Noise in area of steering column after conducting service measure 1709P46C60 "Check mechanical steering column, rework if necessary"

Topic number	LI46.10-P-067941
Version	3
Function group	46.10 Steering wheel, jacket tube, steering shaft, steering lock
Date	05-17-2018
Validity	Model series 204, 207, 212 affected through measure 1709P46C60 "Check mechanical steering column, rework if necessary."
Reason for change	Remedy revised
Reason for block

C.jpg:

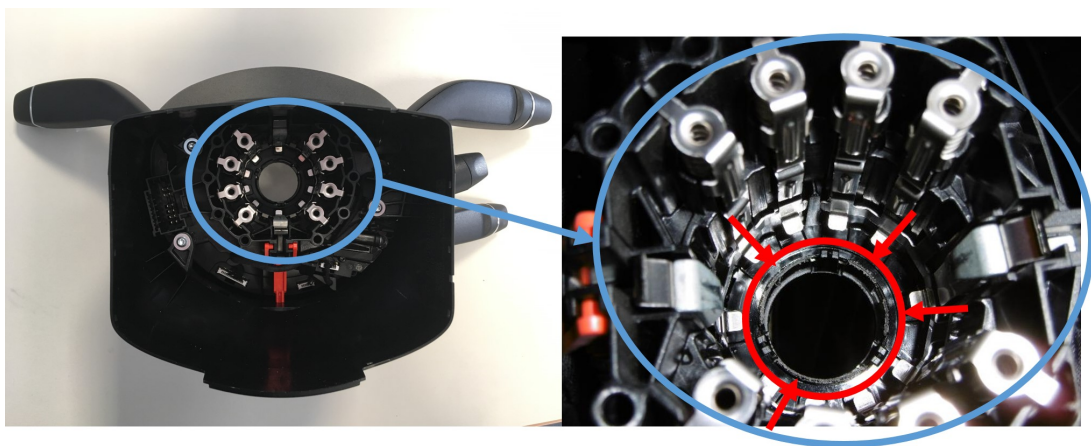
IMPORTANT: The groove on the steering shaft is not a problem (see Attachment C, green marking). This groove serves to ensure that good contact is made and it is supposed to be there.

D.jpg:

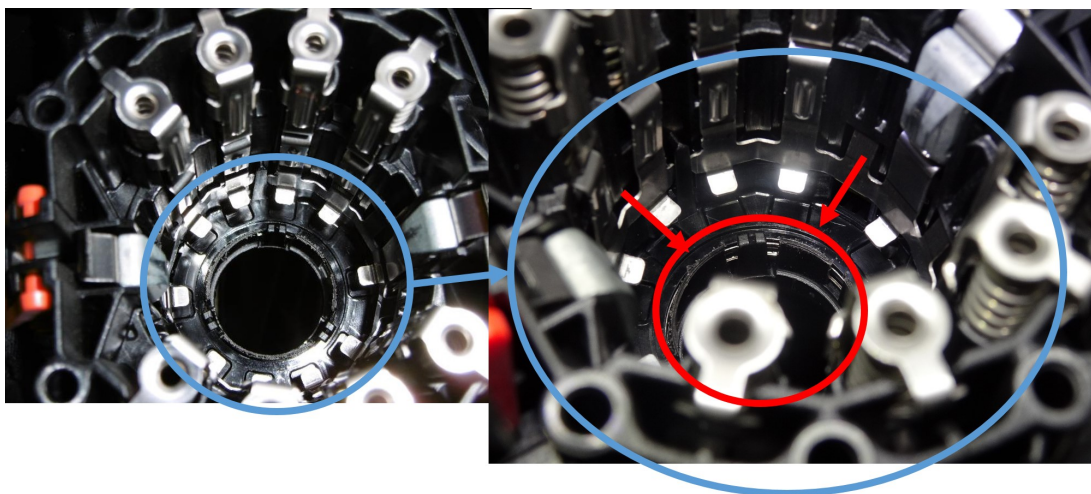
Case 1) Ground off areas on steering column switch module (see Attachment D and E), the plastic lugs are fully intact (see Attachment F, green marking):

Case 2) Ground areas on steering column switch module (see Attachment D and E), at least one plastic lug is damaged or even completely broken off (see Attachment G, red marking):

Replacement of contact bridge with new object number A099 546 04 00 (see Attachment H).

Replacement of contact bridge with new object number A099 546 04 00 (see Attachment H) and steering column switch module (part number as per EPC).
